SB, Fuel Line Contact with Drive Belt, PoulanPro Tractors, PB20A46YT, P20VA46, 10-2017

Description

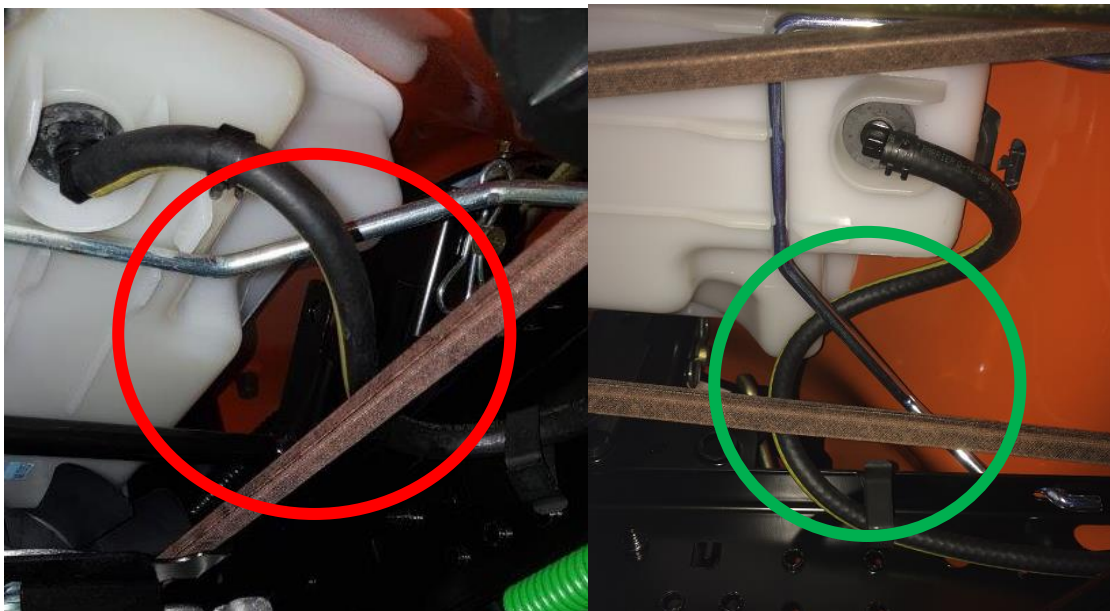
Incorrect routing of the fuel line can potentially result in contact between the fuel line and the drive belt. Contact may result in rubbing and abrasion of the fuel line, which creates the potential for leakage of fuel.

Step 1. Using a flashlight, check the position of the fuel line. The picture on the left shows incorrect routing where fuel line is in front of the silver tank support (red circle). The picture on the right shows the correct routing where fuel line is behind the silver tank support (green circle).

Step 3. If routing is incorrect, disconnect fuel line from fuel tank. Route fuel line behind silver tank support and reconnect to tank. Check that the fuel line clamp is in the correct position.
